Board of Directors
Roosevelt Island Operating Corporation
591 Main Street
New York, NY 10044

June 24, 2009

As an architect, I wish to express my concern about the plan that the Franklin and Eleanor Roosevelt Institute has submitted to you for approval. It is inconsistent with Louis I. Kahn's final design for the FDR Memorial. That design includes two sculptures. One is located outside the open-roofed room. The second is inside the room. This second sculpture has been omitted in FERI's plan.

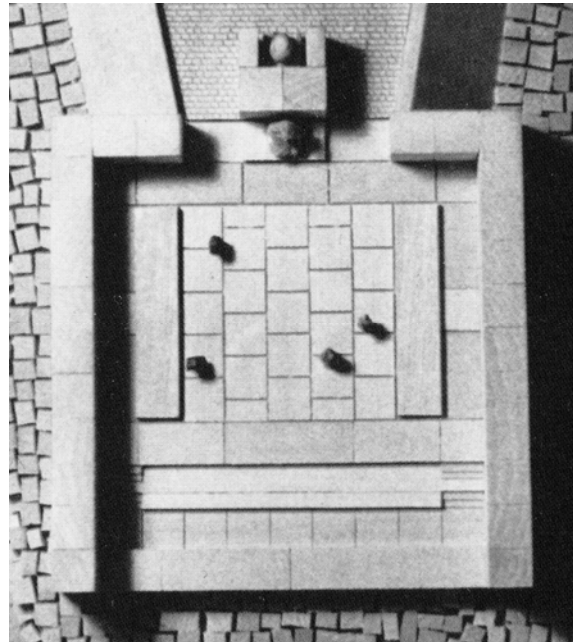
We now enter the...forecourt, into which at the southern end is placed the plinth on which is the lifesize standing statue of Roosevelt.

...our focus is to the view downriver or to the seated statue of Roosevelt on the opposite side of the wall around which we entered.

A portion of the following image, showing a sculpture of a seated Roosevelt, accompanied the article.

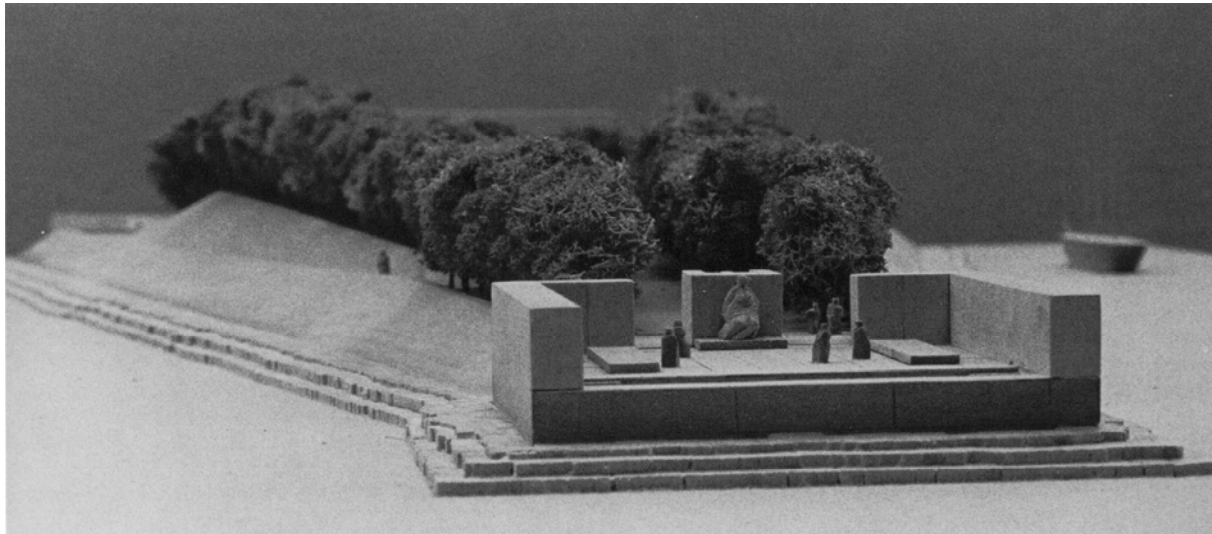
The removal of this sculpture and its plinth would be a significant departure from Kahn's design. The sculpture and plinth align with the six-foot depth of the adjacent walls, continuing the perimeter of the room and giving justification to the offset to the north of the twelve-foot-tall walls behind the sculpture. Additionally, the absence of the plinth would leave the two entrances to the room less well defined and would alter the composition of the low stone elements in the room.

If you agree, I respectfully suggest that you must help make it happen by withholding your approval of the FERI plan until the absence of the second sculpture and other discrepancies are resolved and an appropriate recognition of FDR's disability is planned. After 35 years, it's worth taking the time to get it right.

Restoring the omitted sculpture would return the Memorial to Kahn's design and provide an opportunity to represent FDR's disability within the Four Freedoms Park.
